Volvo Truck / Goldline/MT
RSMAD010079

Volvo Truck/Goldrare/MT-DG
REM0010589 左右上鏡座蓋
REM0010625

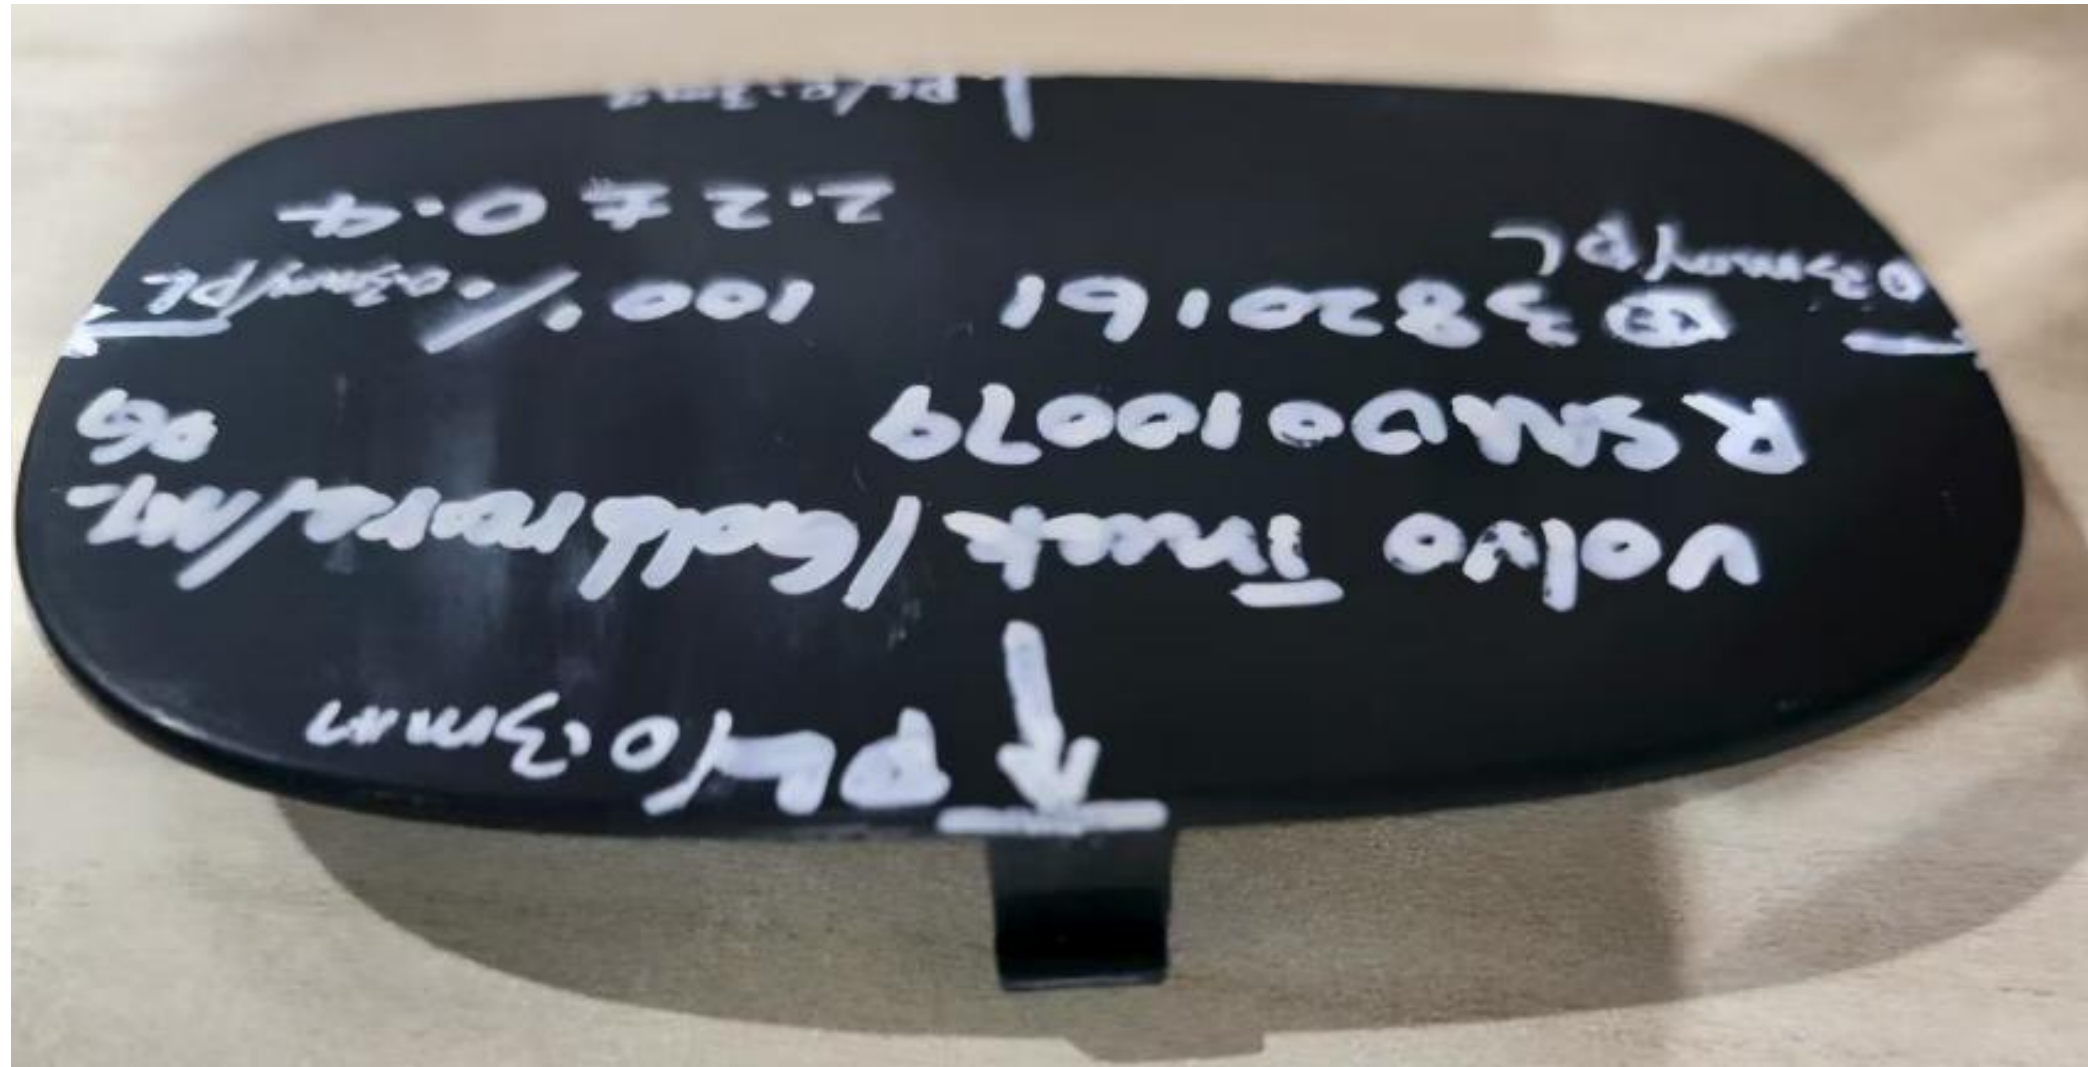
Parting Line have 0.3mm free band (matt finish)

VT DQ: Reduced to 30% OK

Volvo Truck / Gøbbørn / MT-DG
REM 0910589
REM 0010625
ID 3820161100%
22404

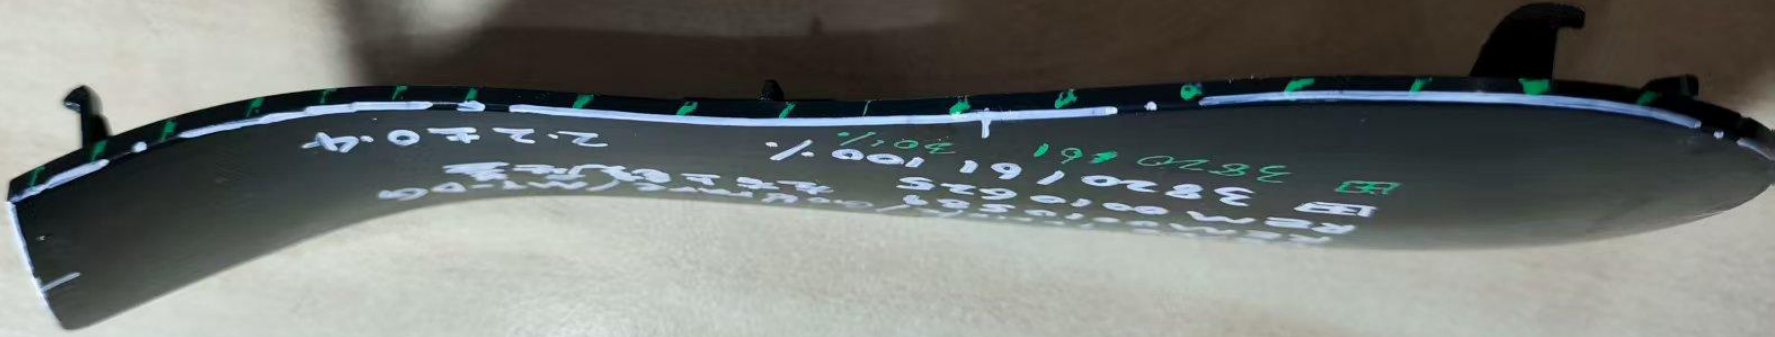
Parting Line have 0.3mm free band (matt finish)

VT DQ: Reduced to 30% OK

Volvo Trucks / Goldrave / m...
REM 0010601 主气轮
3820161 60% 2.2 ± 0.4

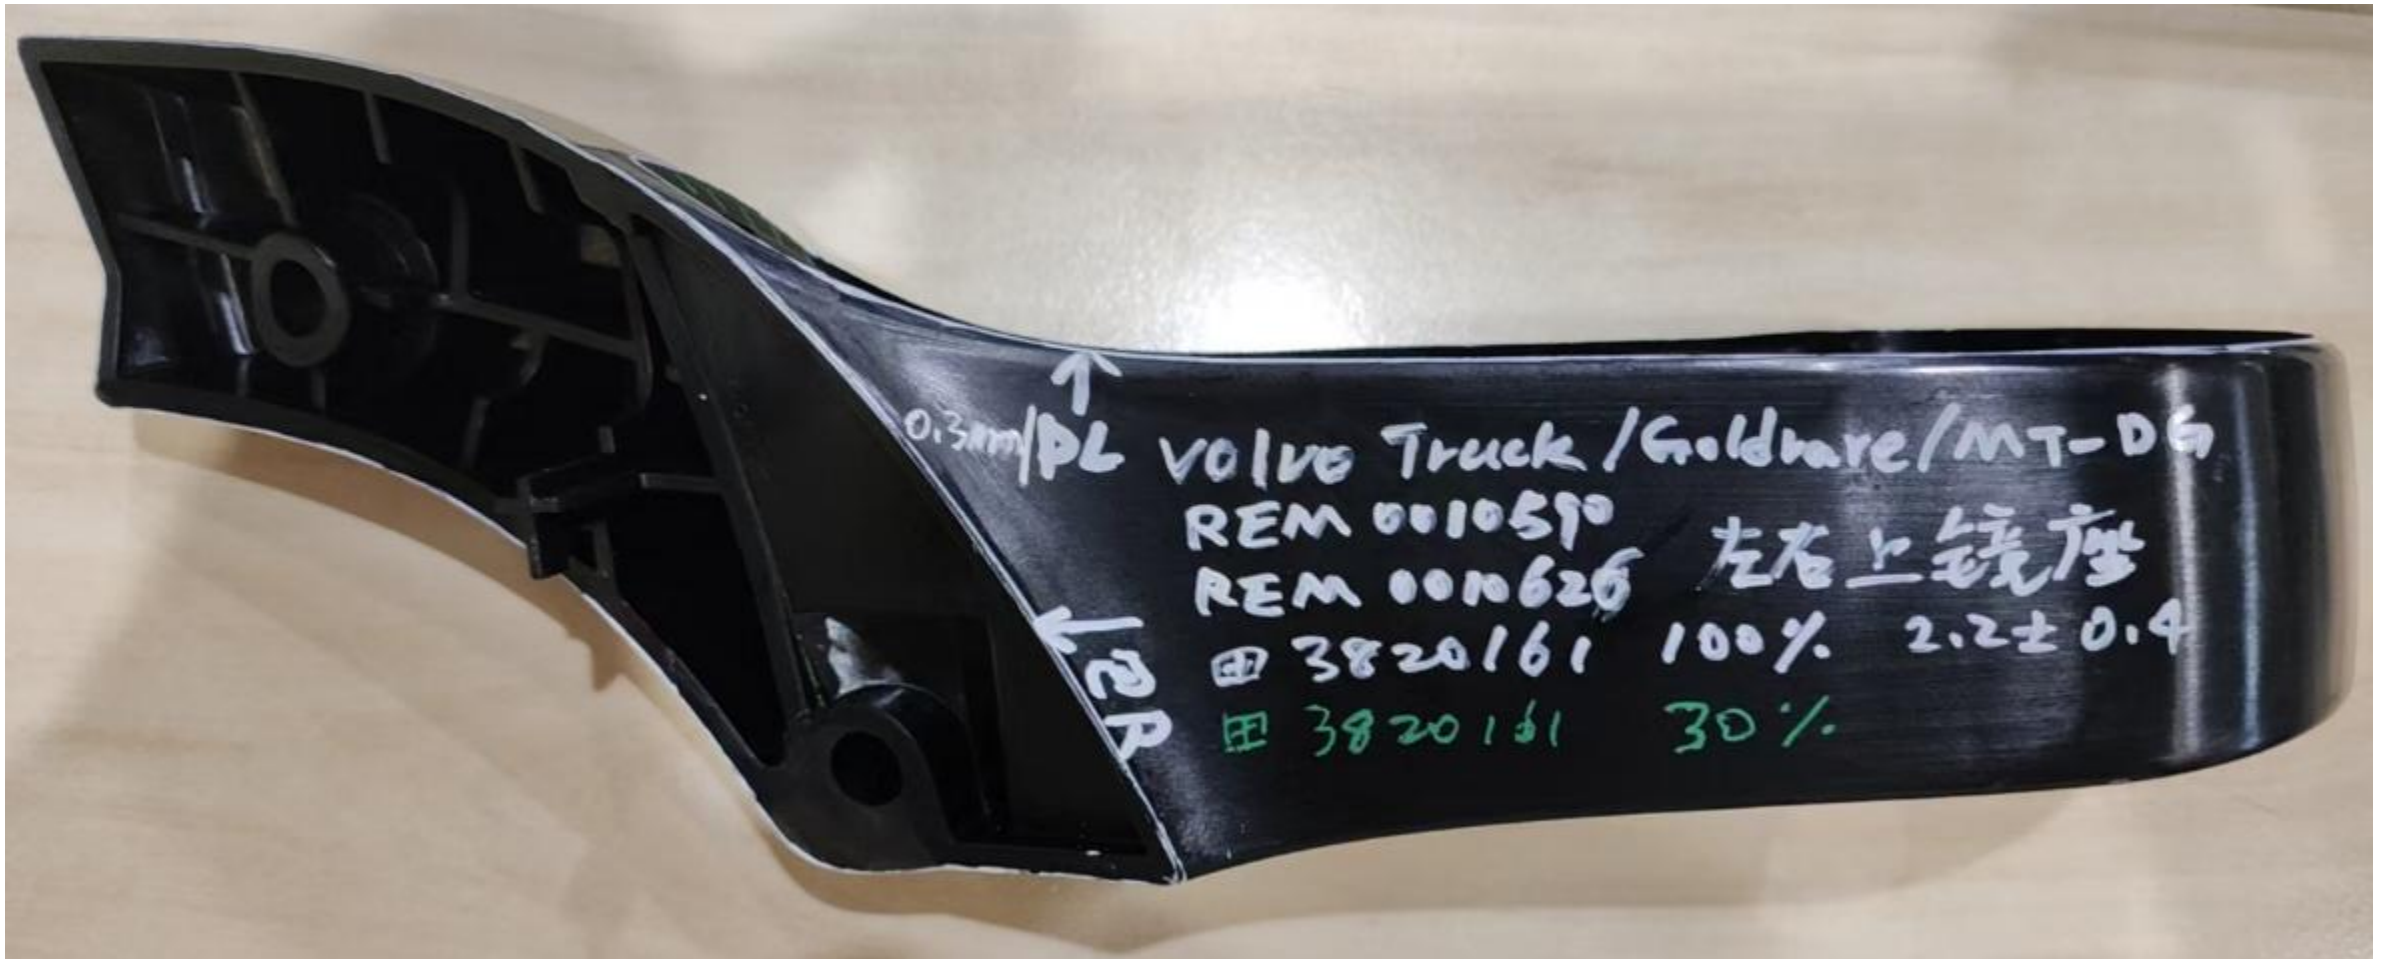
VT DQ: On part 60%, in text 100%, which is it?
(OK)

MT: Sorry for typo, 60% is the right one

VT DQ025w42: Reduced to 60% OK

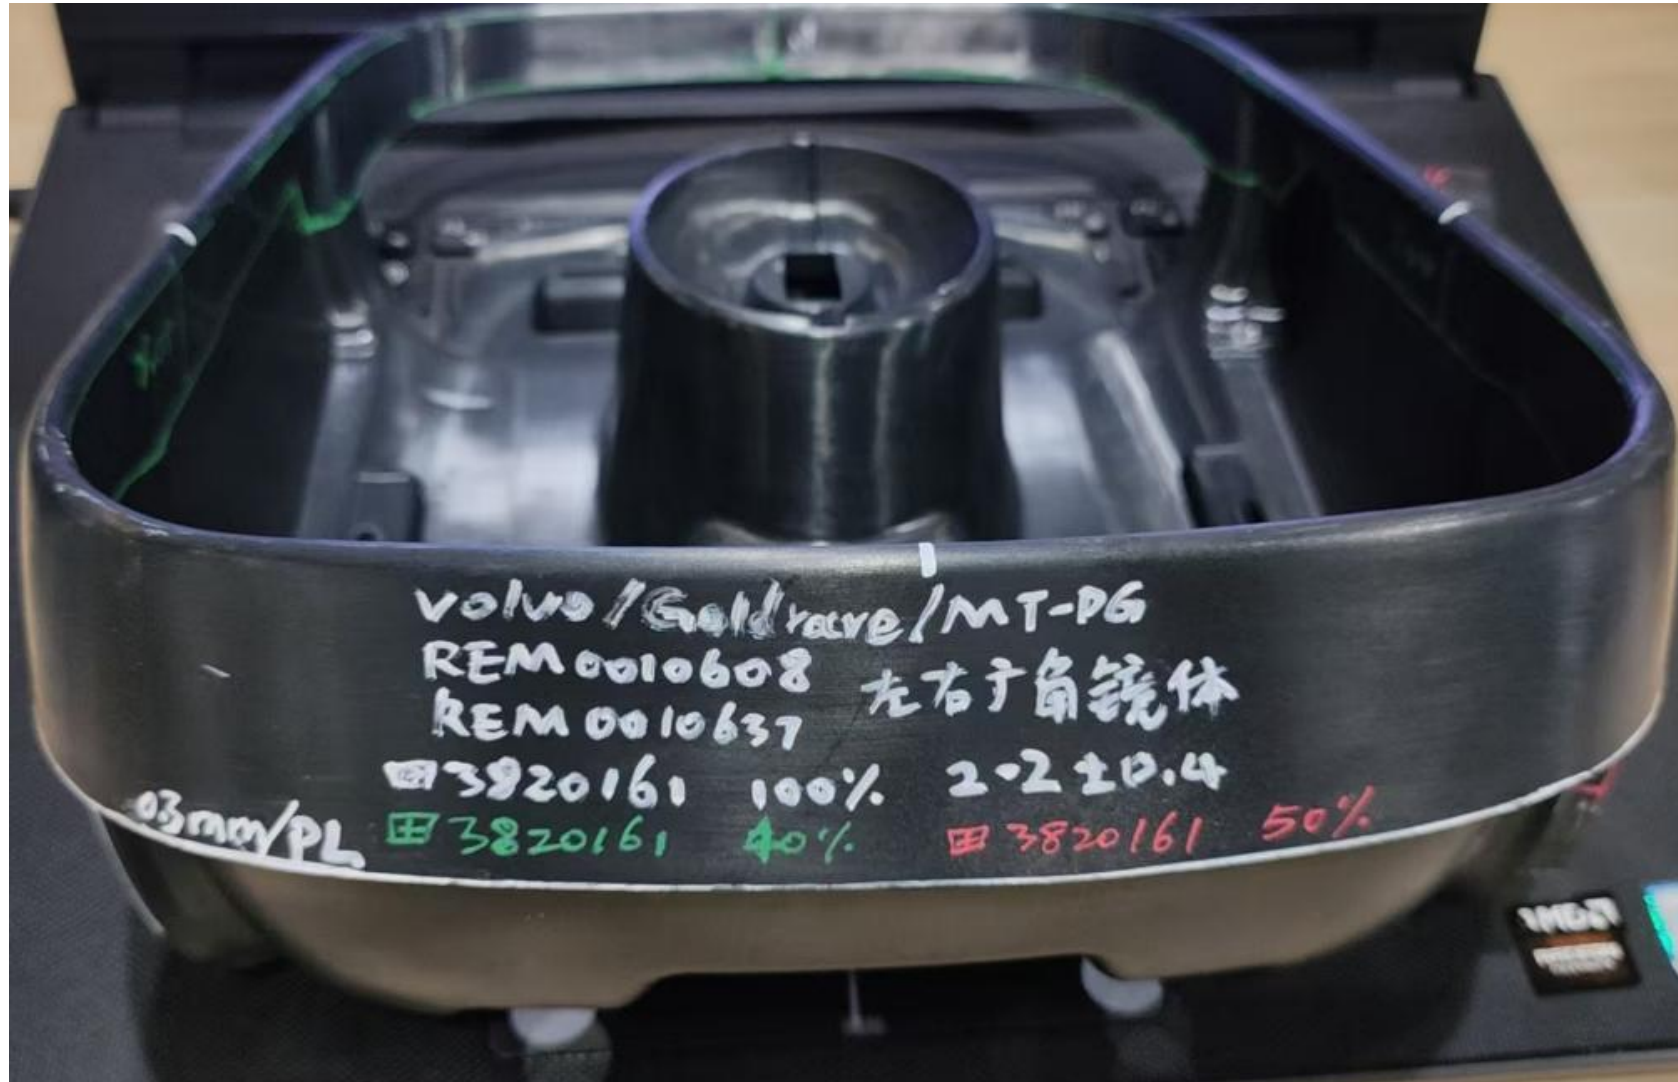
VT DQ: Reduced to 40% OK
Why under 50%?
Please confirm draft angle.

MT: Here draft angle is 3 degree, On-shrinkage condition 50% depth need 4 degree.

VT DQ 25w42: Reduced to 40% OK
Reduced to 50% OK

volvo Truck
REM0010609
REM000636
⊕ 3820161
⊕ 3820161
⊕ 3820161
REM Goldrose / INT-DS
REM 0010722
REM 0010721
2.5米
左右角
铁体
100%
40%
50%

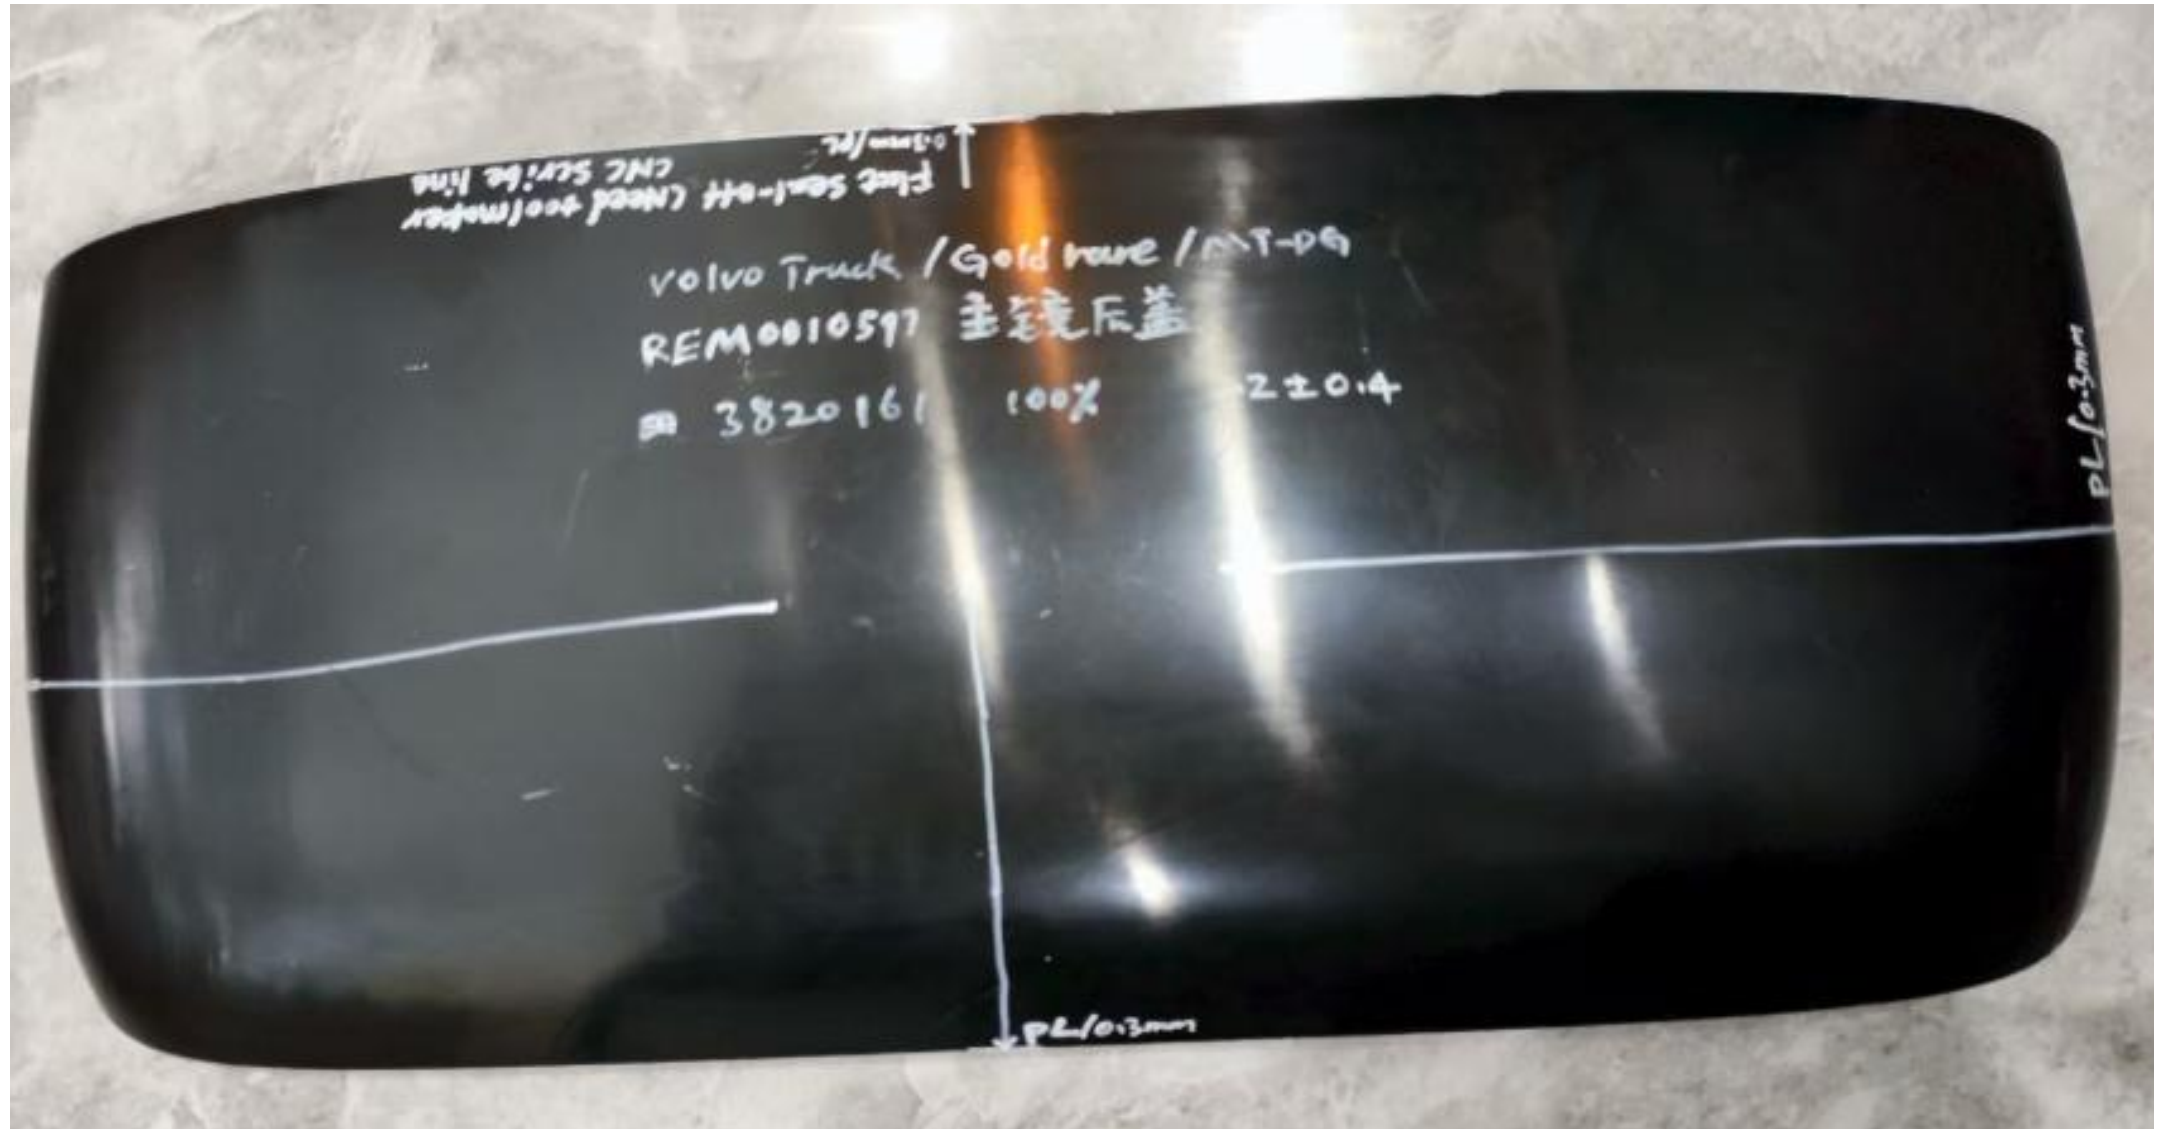
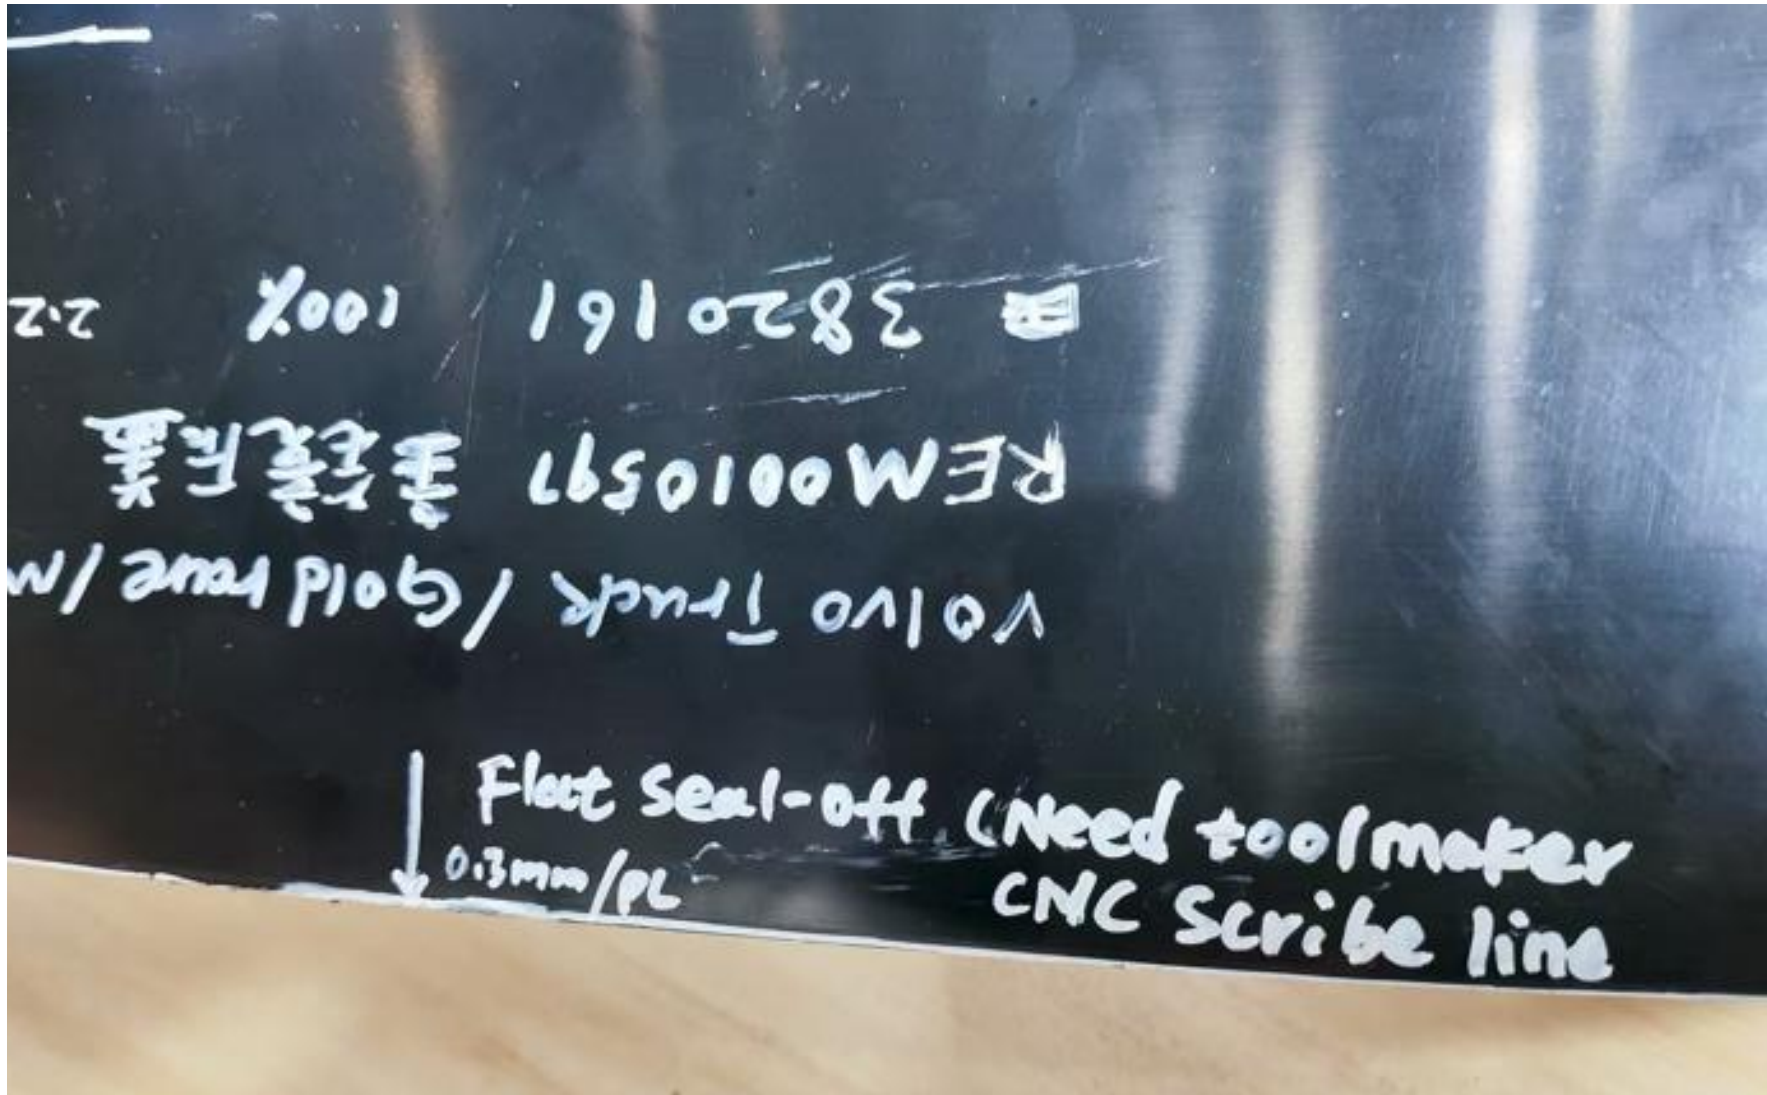
VT DQ: Reduced to 40%
Why under 50%?
Please confirm draft angle.

MT: Here draft angle is 3.4-3.7°, On-shrinkage condition 50% depth need 4 degree.

VT DQ: Reduced to 20%
Why not 25% if draft is 1°
(4° total depth)?

MT: Because of the draft angle is too small, and the part is big, small deformed and shrinkage will effect on the part release lead to scuffing issue, so we suggest reduced to 20%, but still have risk to scuffing

VT DQ 25w42: Reduced to 40% OK
Reduced to 50% OK

VT DQ 25w42: Reduced to 20% OK
